Serra Mesa Planning Group

May 18, 2017

RE: Serra Mesa Community Plan Amendment Roadway Connection Project
Project No 265605

Analysis of the LOS Level Long-Term Baseline vs Long-Term Cumulative with Project - These charts are based on Tables 5.2-16 and Table 5.2-17. Analysis worksheets are in the Addendum, p. 5-8.

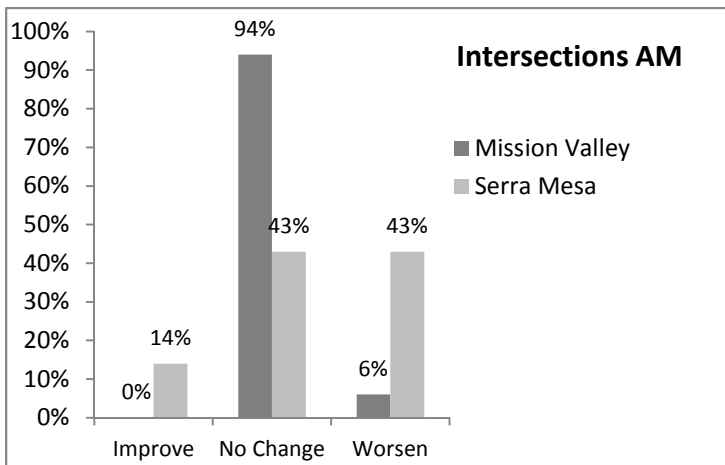
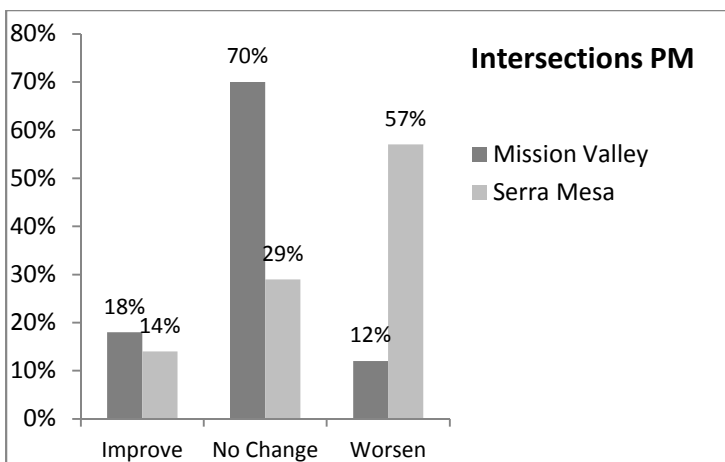
In both Serra Mesa and Mission Valley the greatest percentage of the roadway segments will receive the same LOS level. Also, in Serra Mesa one-third of the segments will worsen and none will improve.

The LOS No Change is almost 100% percentage for Mission Valley while in Serra Mesa both No Change and Worsen receive the same percentage.

In Mission Valley 70% of the intersections won't change LOS level while in Serra Mesa more than half of the intersections will worsen.

Shows Emergency Access at Kaplan and Aperture Circle and
Sidewalk (switchback) adjacent to Kaplan from Ainsley to Aperture Circle

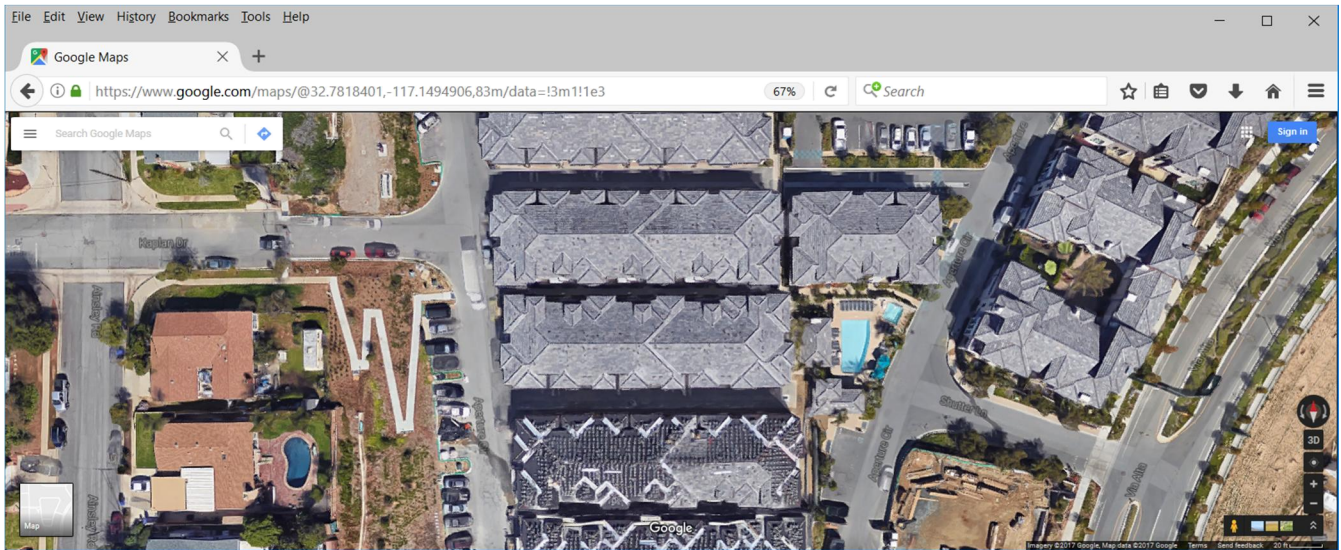
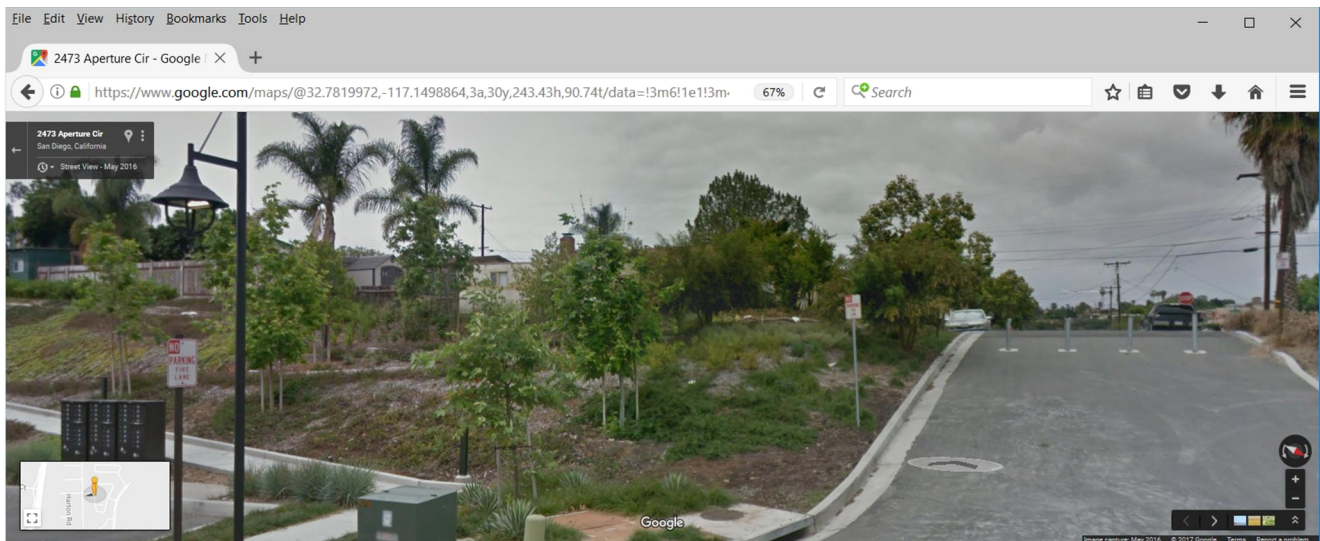
- Emergency access via Kaplan Drive in Serra Mesa which is located adjacent to Civita housing exists. Why wasn’t this considered in the Recirculated DEIR? (C. Street and Freeway System Goal I)

- The completed emergency access and sidewalks at Kaplan Drive provides for bicycle and pedestrian access. Why wasn’t this considered in this Recirculated DEIR? (Policy LU-H.6; A. Walkable Community Goal II; A. Walkable Community Goal III; A. Walkable Community Goal IV; A. Walkable Community Goal IV; Policy ME-A.6; C. Street and Freeway System Goal I; F. Bicycling Goal; Policy UD-A.2; Policy UD-B.5; Policy UD-C.6; Policy UD-C.7; 1)

I-805 Phyllis Place Bridge – Shows Lanes over the Bridge

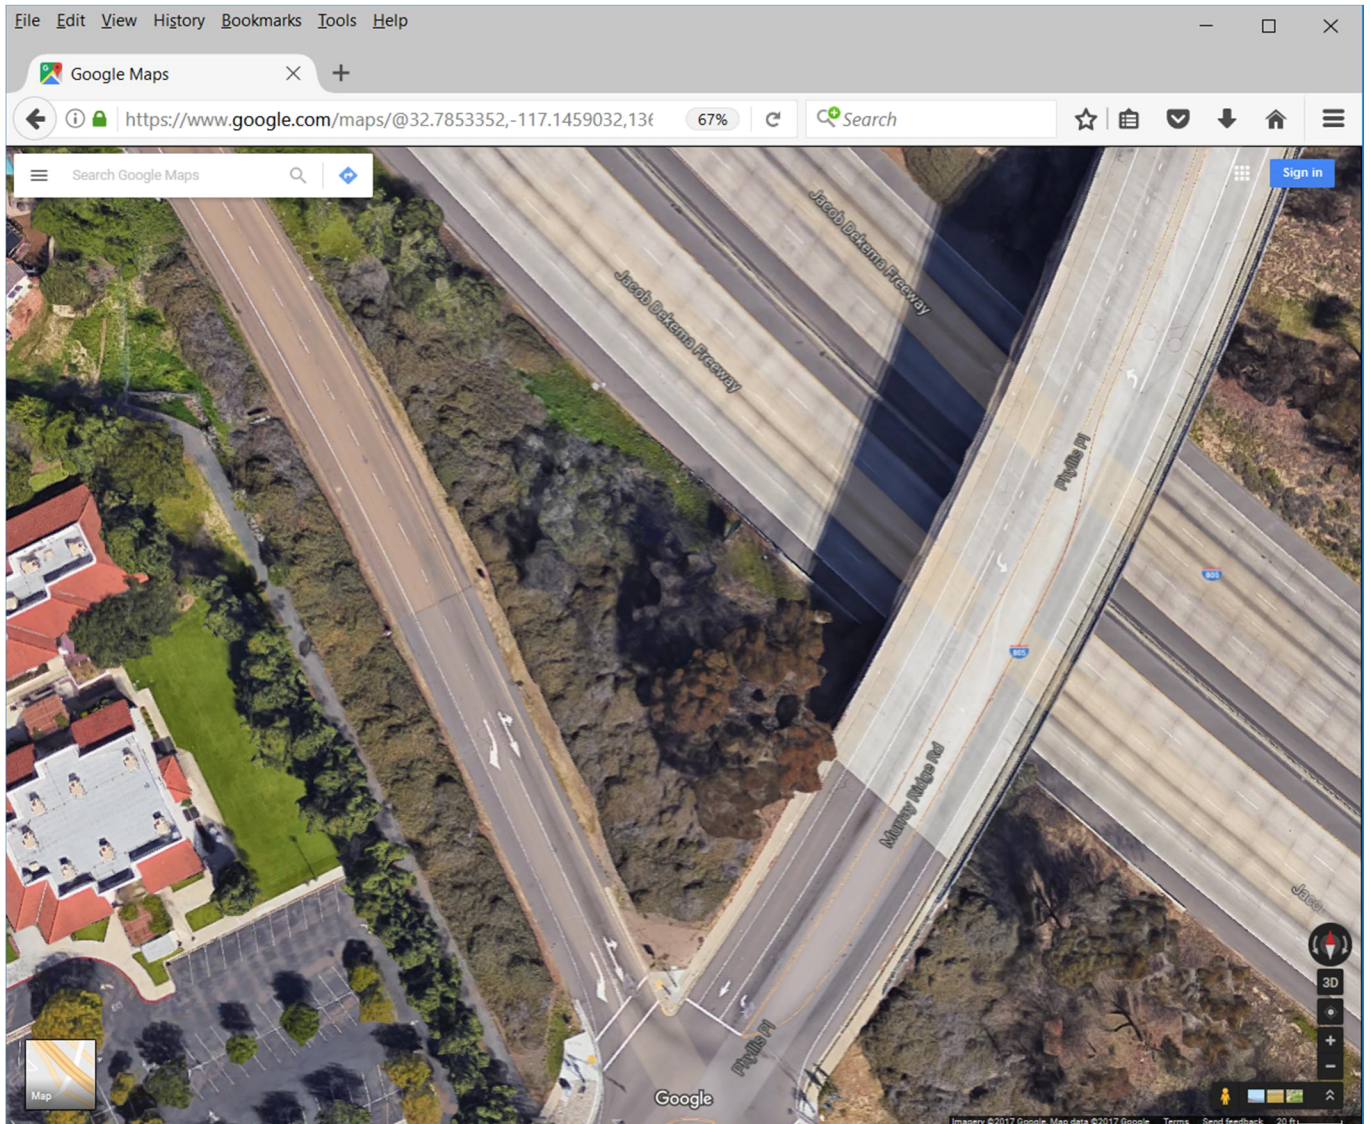
- Since the bridge will be restriped to add additional lanes has an analysis been conducted to determine the capability of the I-805 bridge to withstand the added stresses of maximum tonnage of cars queuing and their engines vibrating on the bridge at peak times been done? If not, provide an explanation for the exclusion.

- Will the reconfigured road meet the City's design standards? If there are any exceptions, what are they?
 - In the Final PEIR for the Quarry Falls Project Transportation Phasing Plan, #8b Murray Ridge Road Bridge over I-805, it states "Prior to the issuance of any building permits for Phase 1, the applicant shall assure by permit and bond the restriping of Murray Ridge Road/Phyllis Place, between the northbound and southbound ramps to I-805 ramps, to 5 lanes, satisfactory to the City Engineer." (p. 11-4) The Murray Ridge Bridge, as viewed in the p. 10 of the Addendum, shows 4 lanes and Civita (Quarry Falls) has been issued building permits.
